**PLANNING, ZONING, & BUILDING DEPARTMENT**  
**PZ&B Staff Combination Memorandum: Architectural Commission and Town Council**

**SUBJECT:** ARC-23-015 (ZON-23-021) 320 CHILEAN AVE (COMBO)

**MEETING:** JUNE 28, 2023 ARCOM  
JULY 12, 2023, TC

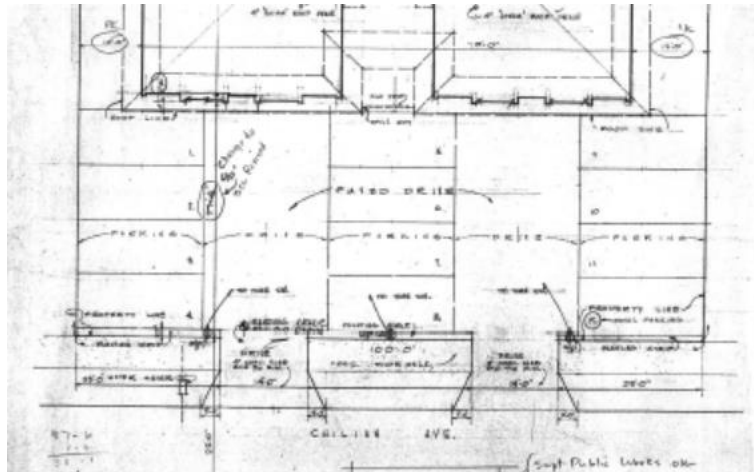
As it pertains to **Variances 1-3**, the applicant is proposing a new 8' x 20' pool in the east side yard of the building that encroaches into the required setback. As designed, the pool is located 2'-8" closer to the side property line than permitted (Variance 1). Additionally, the applicant has placed all the mechanical equipment within the south side yard of the building. This location exceeds the 25' maximum distance separation for pool equipment when the equipment is located within a building setback (Variance 2)—as proposed, the configuration is over 30' from the water's edge. See variance graphic below.

In addition to the pool pump and filtration system, there is also a proposed pool heater, which has a more restrictive side setback of 10'-0", rather than 5'-0" setback required other pool equipments (Variance 3). Staff maintains that the applicant should continue to explore ways to eliminate all of the variance requests for the installation of an amenity feature, as the reduced setback may negatively impact the neighboring duplex property.

**1964 Paving Configuration**

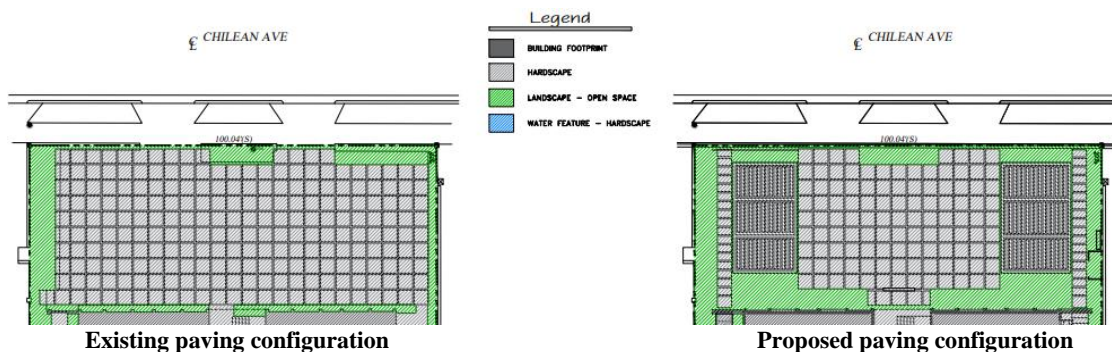
As it pertains to **Variances 4-5**, the applicant is proposing a redesign of the front yard and motor court area. The entire front area is configured as a large, paved car park area. The original 1964 design had an even greater area dedicated to car parking. See graphic below.
